6672A-11

S E R V I C E N O T E

**6672A DC POWER SUPPLY, 0-20V, 0-100 A, 2000 W.
MANUALLY CONTROLLED.**

Figure 1

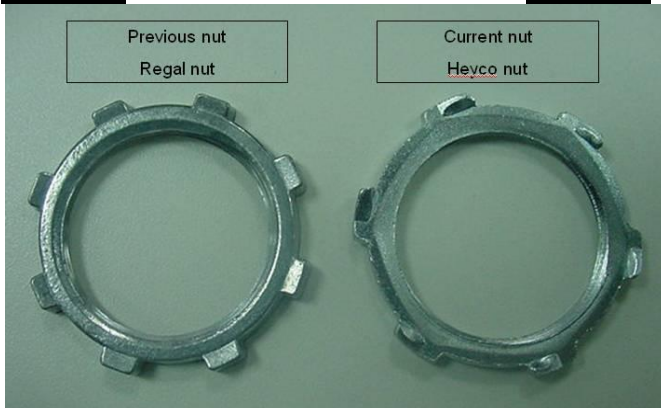
When the incorrect nut is used or a locking Nut is put on incorrectly the strain relief will become loose.

Figure 1 is an example of what happens when the strain relief becomes loose, the line cord becomes twisted. When a heavy line cord is used the strain relief becomes loose very easily, and the line cord cable can rotate freely.

Figure 2 shows the inside of the AC Safety Cover housing the incorrect hardware is shown. It will be very difficult to tighten the strain relief. AMC (Asian Manufacturing Center) uses a special tool to tighten the locking nut. When the incorrect nut is used or a locking Nut is put on incorrectly the strain relief will become loose as described above.

The entire **AC INPUT SAFETY COVER** P/N 5040-1676 should be replaced.

The line cord should be securely fastened at a point 6 to 12 inches away from **INPUT SAFETY COVER** as shown in [Figure 7](#). When this type of strain relief is used the electrical code requires the cord/cable being held by the strain relief be secured. Doing this eliminates the cable or cord from being twisted as shown in figure 1.
